A D D E N D U M N O. 2

REBID MAGNOLIA BEACH FIRE STATION PROJECT

CALHOUN COUNTY, TX

July 6, 2026

PAVING PLAN
 SCALE: 1" = 20' C5

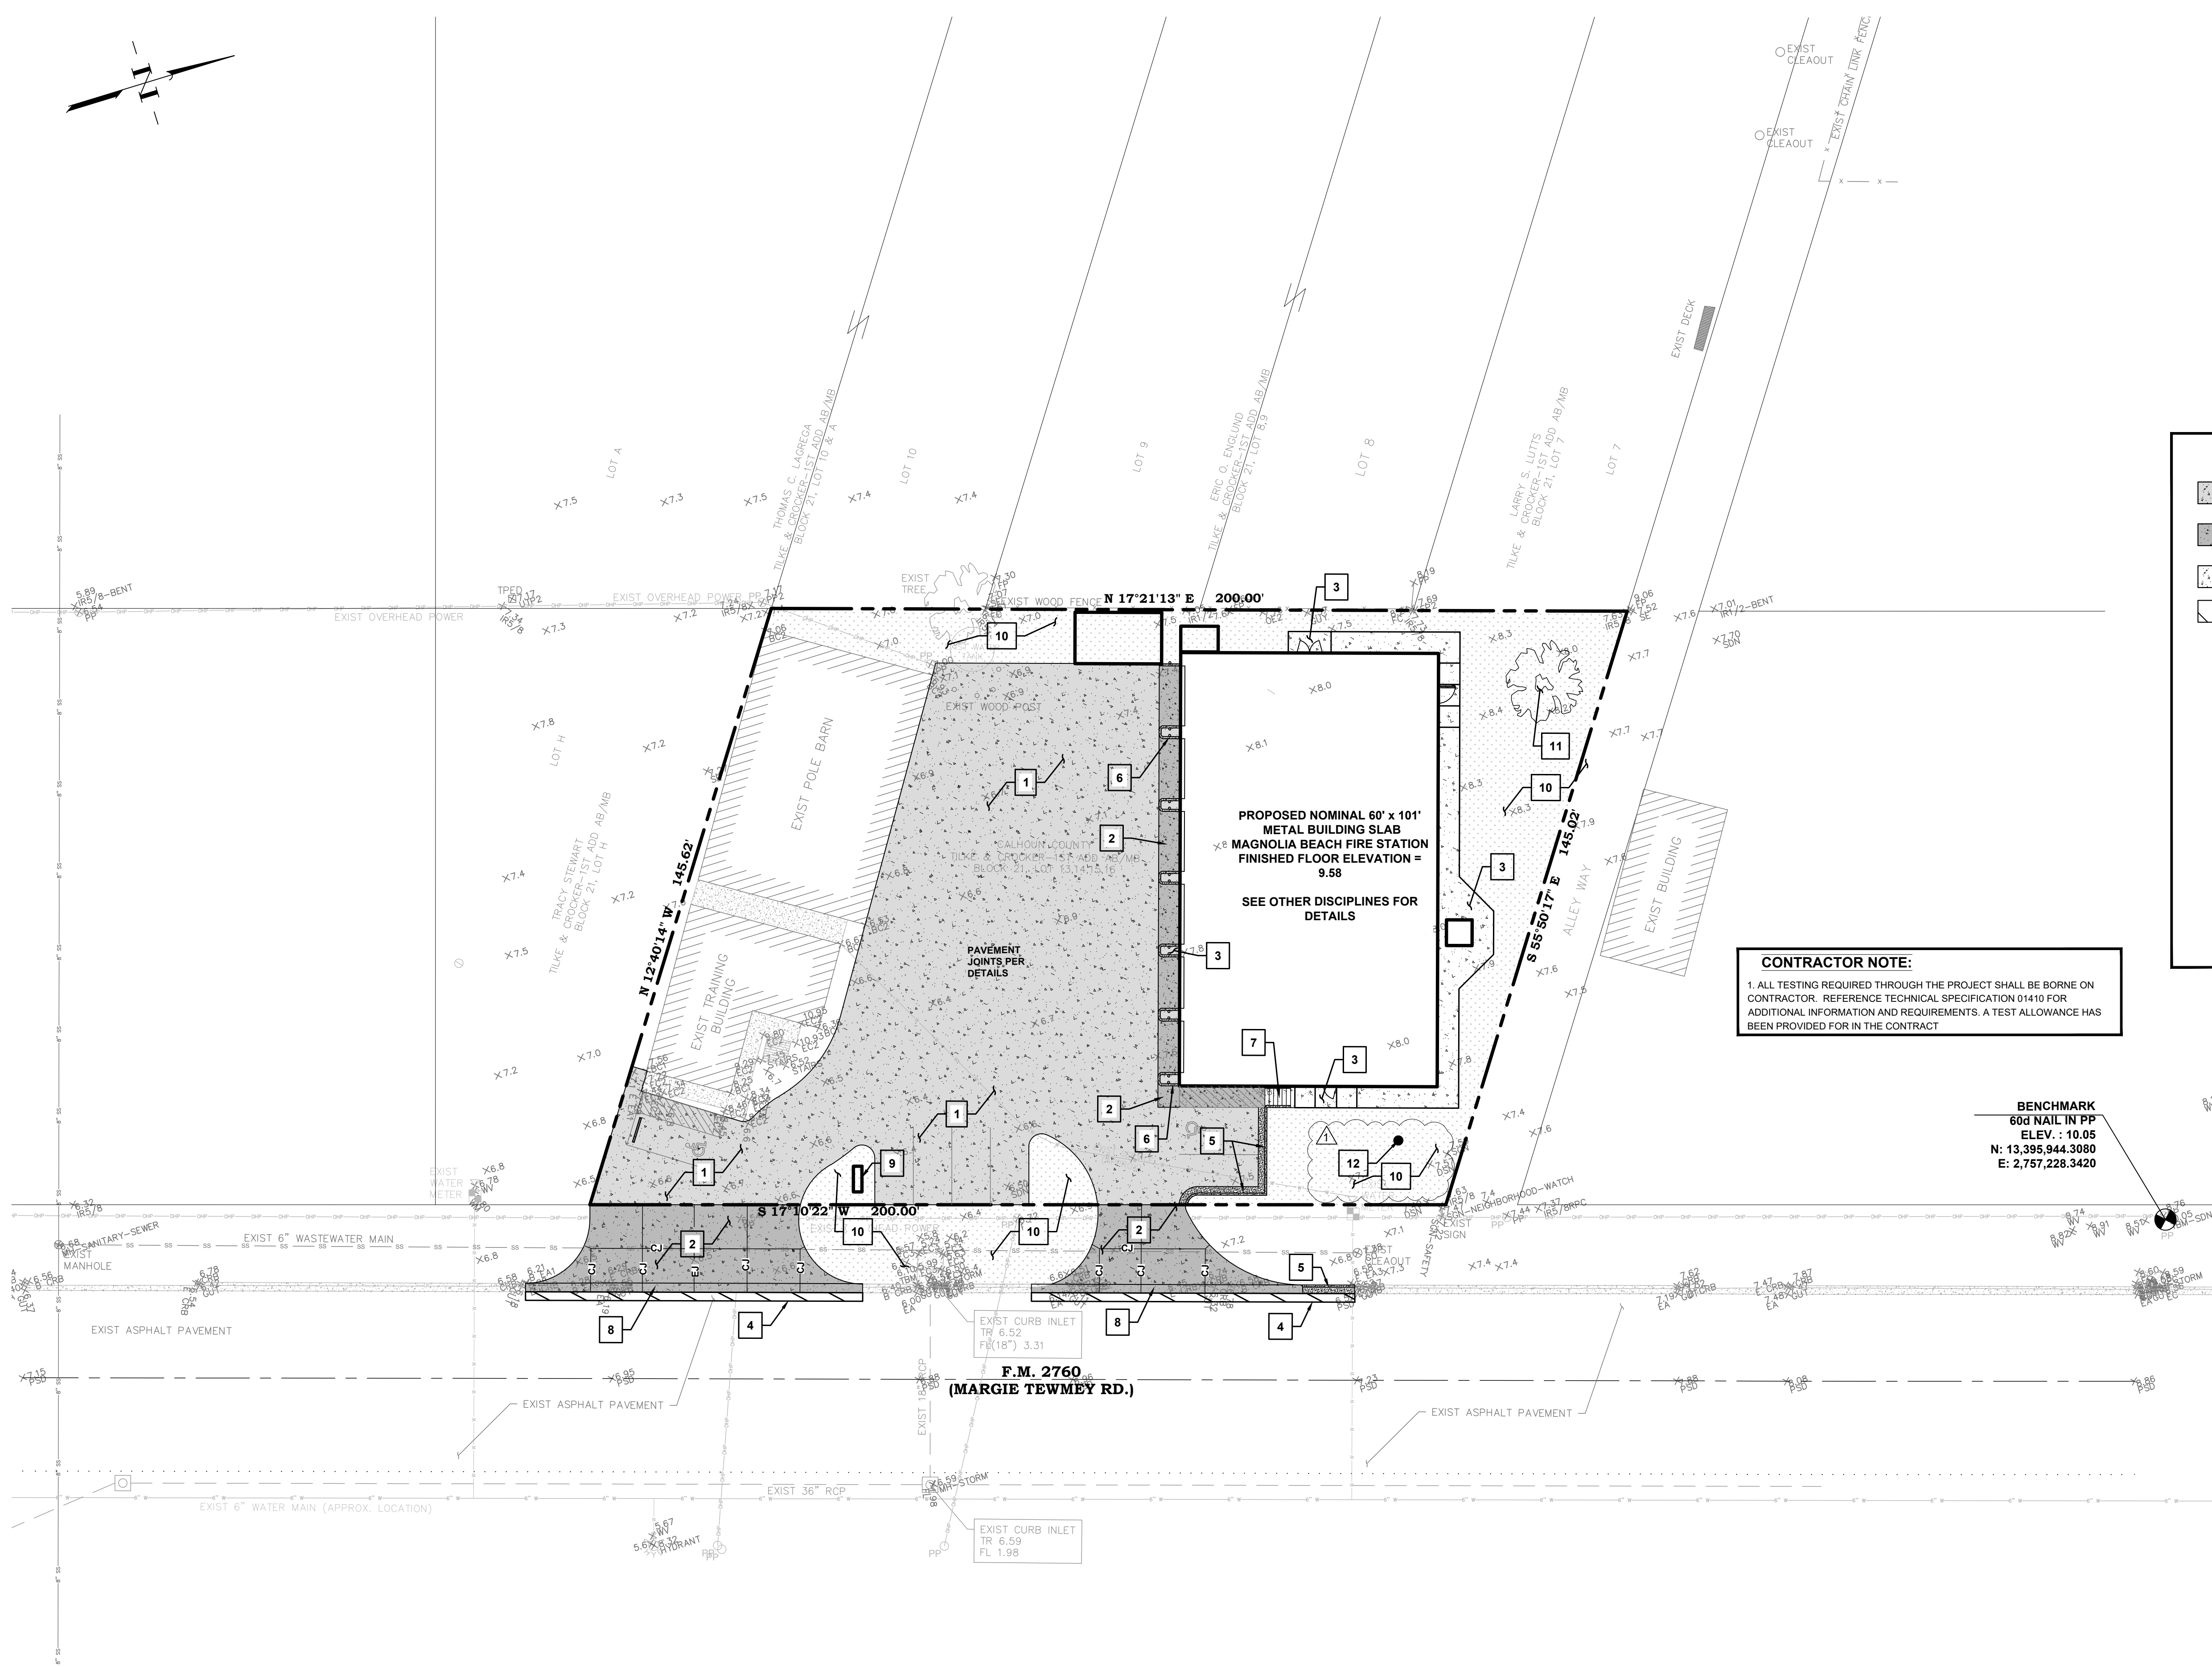
REMOVE: C5, A1.1
REPLACE with: C5 (Rev. 1), A1.1 (Rev. 2) (All signed and sealed on 07.06.26)
EXPLANATION:
C5 – Added aluminum flag pole location.
A1.1 – Revised finish table and notes

A flag pole is not shown on plan view but there is a detail confirm if we are to bid out the flag pole.

Answer: A flag pole location has been added to Sheet C5. Please coordinate with the owner for exact location
